Mr. Dwight Russell, P.E.
Municipal Solid Waste Permits Section – MC 124
Texas Commission on Environmental Quality
12100 Park 35 Circle; Bldg. F
Austin, Texas 78753

Re: Pescadito Environmental Resource Center - Webb County
Municipal Solid Waste (MSW) Permit Application No. 2374
Notice of Deficiency - Technically Complete Permit Application Supplement Number 5
Tracking No. 21876231; CN603835489/RN106119639

APTIM Environmental and Infrastructure, Inc. is in receipt of your letter dated October 23, 2017 in which you are asking for additional information and clarification related to our submittal of August 17, 2017.

**FIGURE 1 - PART 1
GENERAL LOCATION MAP**

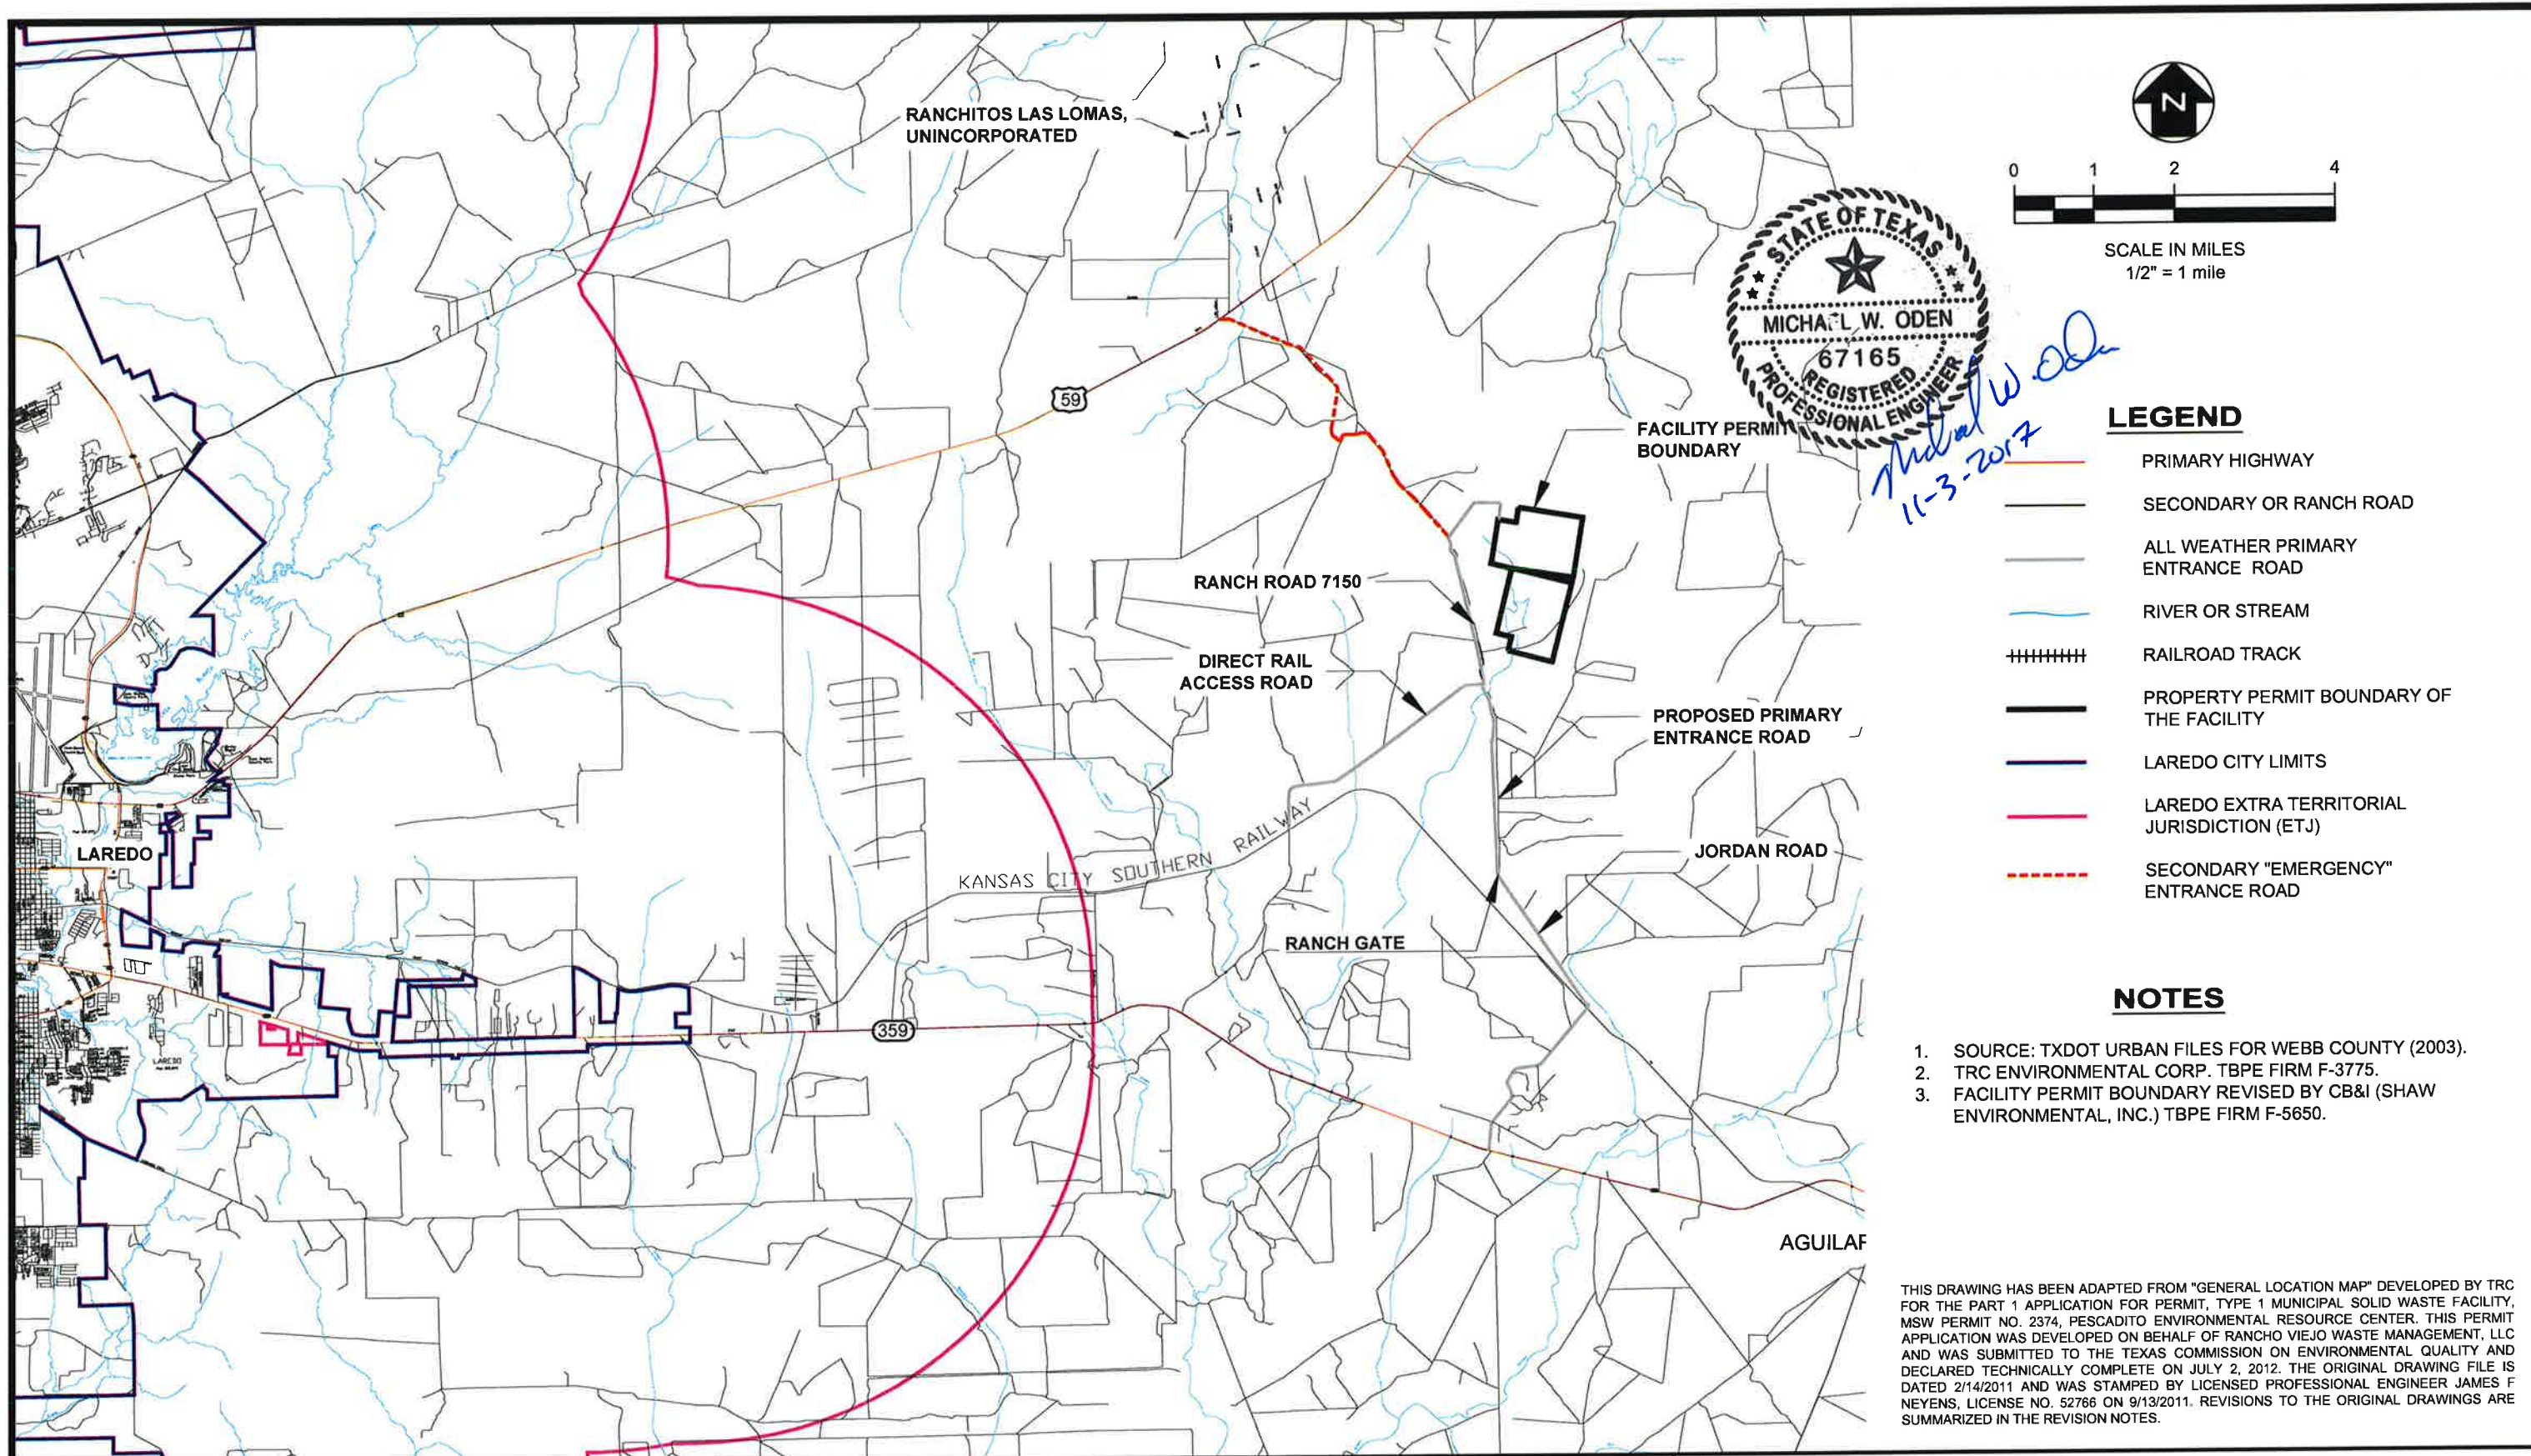
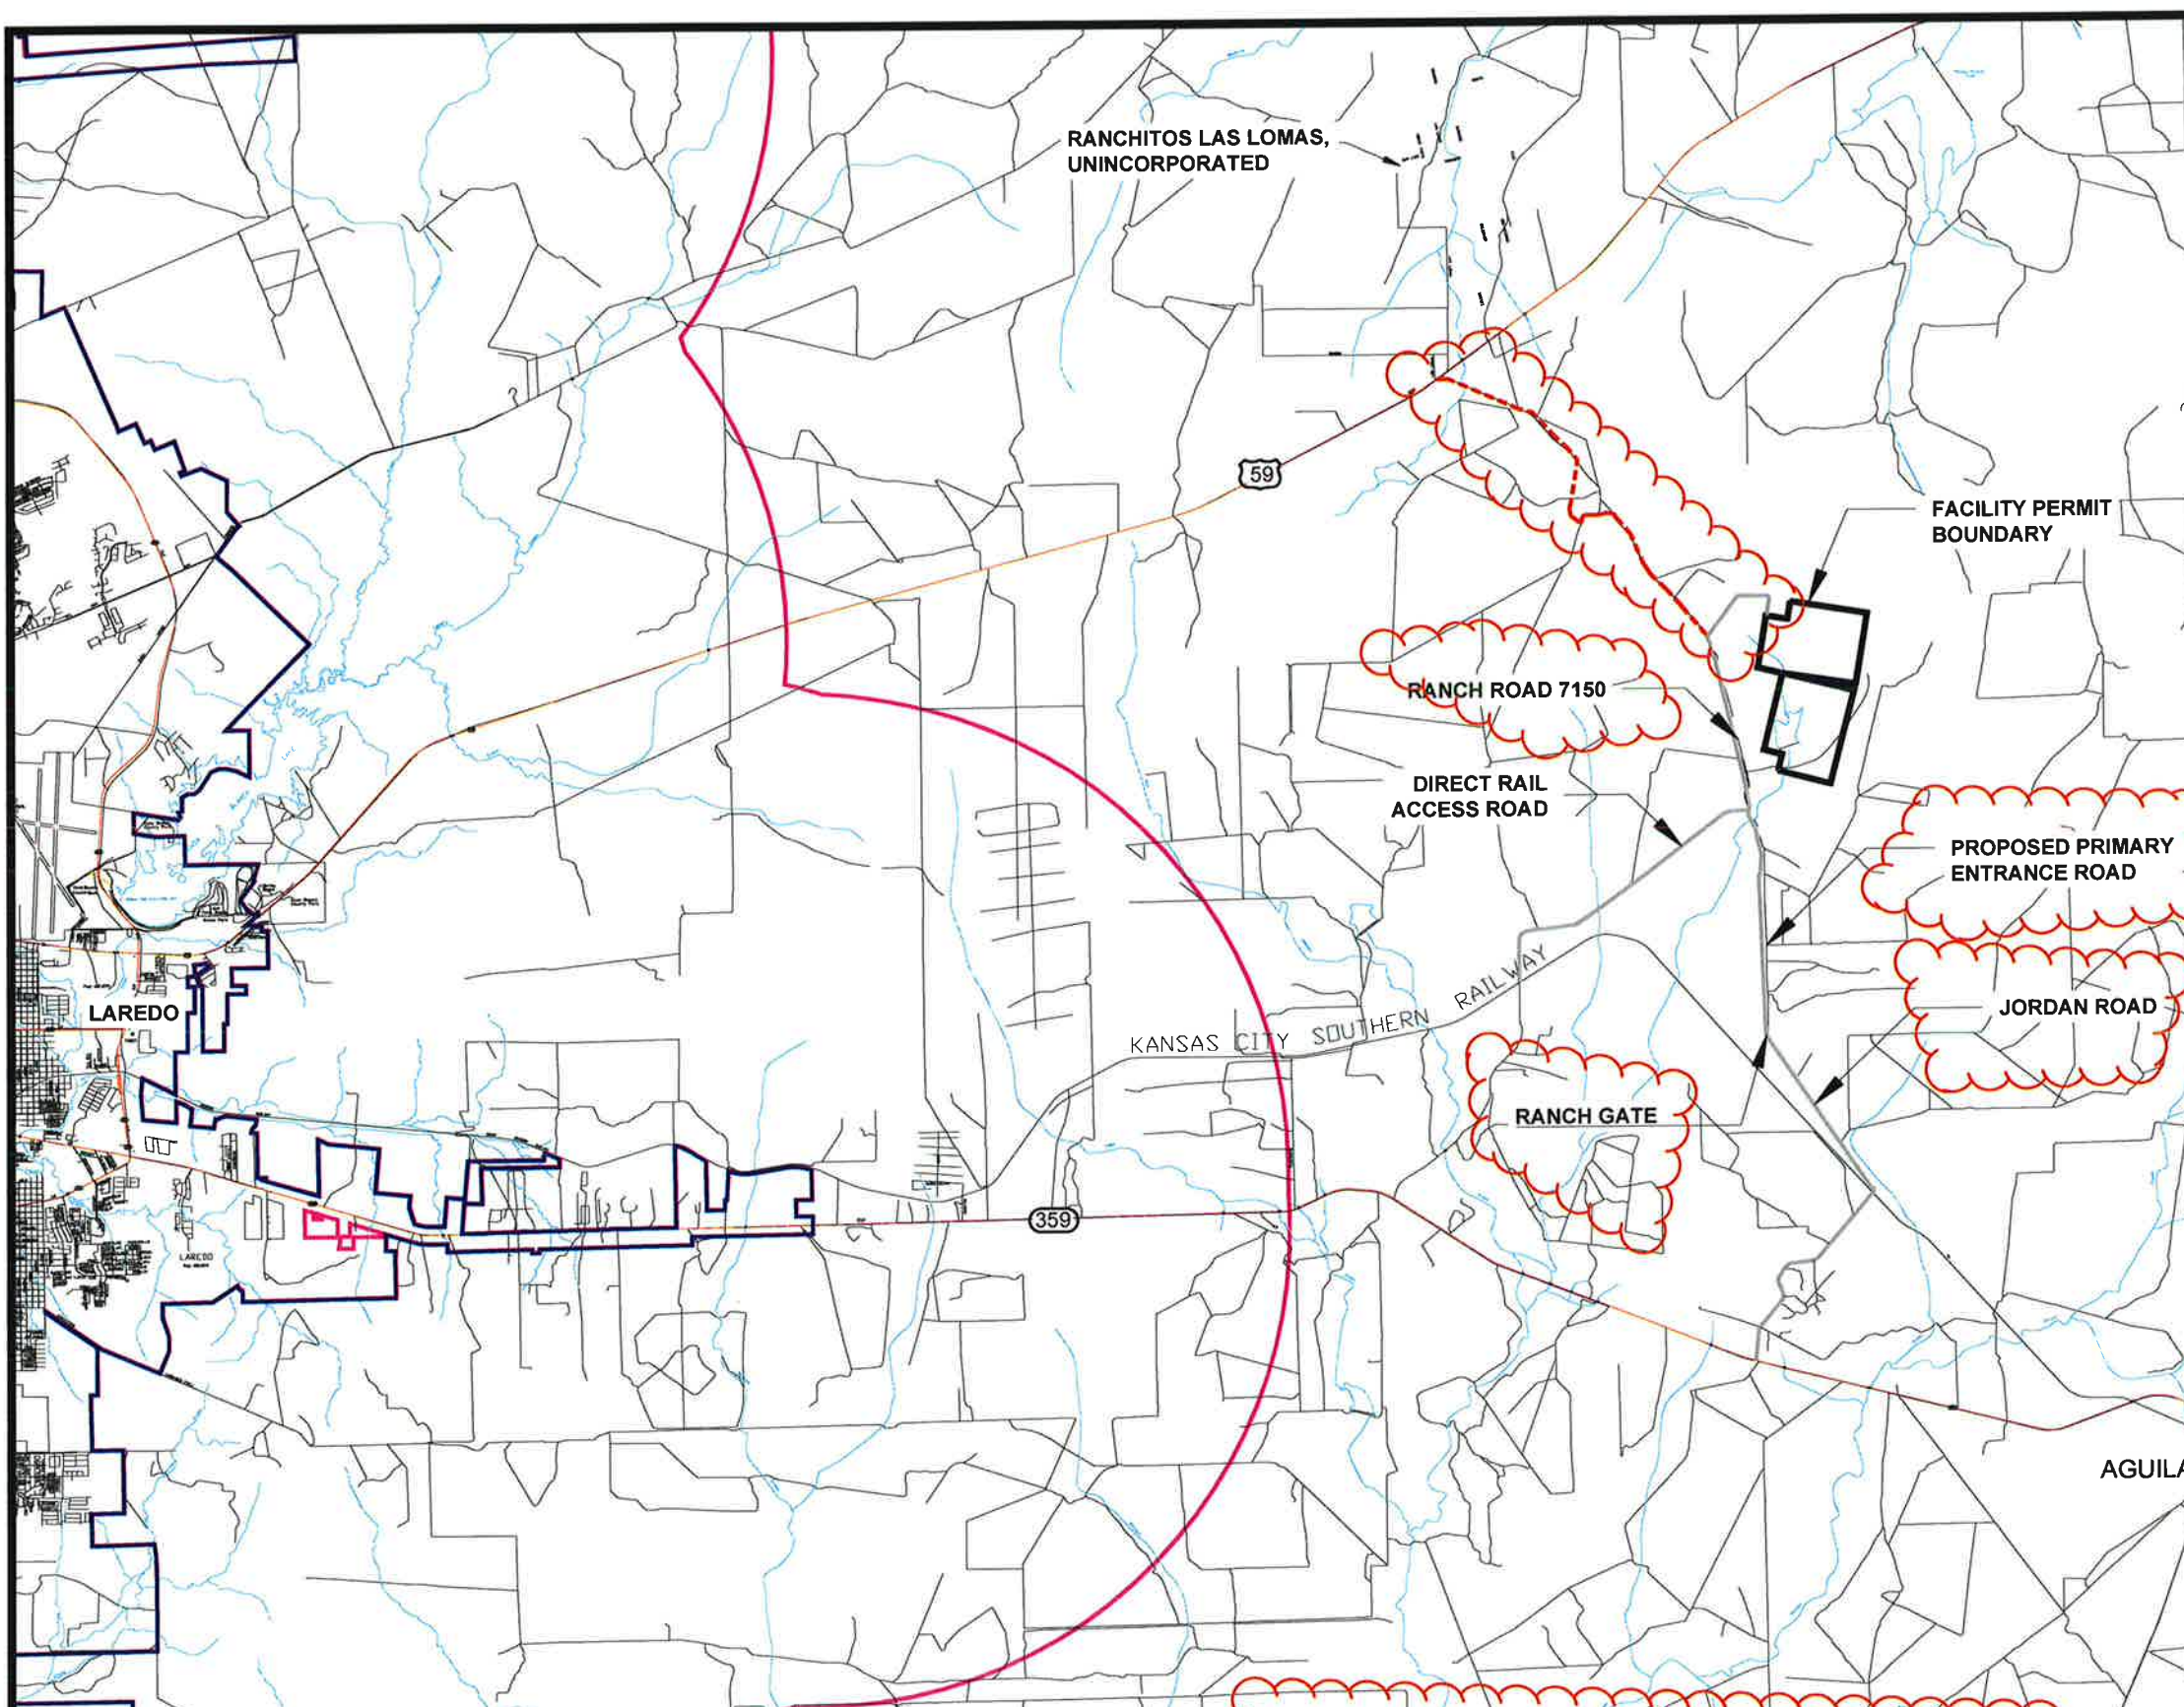
- 1) In accordance with §330.61(d)(8), Part I, Figure 1 should be revised to accurately depict the site entrance roads from public access roads north and south of the facility that are described in Part I, Page 5.

Part I, Figure 1 has been revised as requested. For consistency, Part I, Figure 2 has been revised as well.
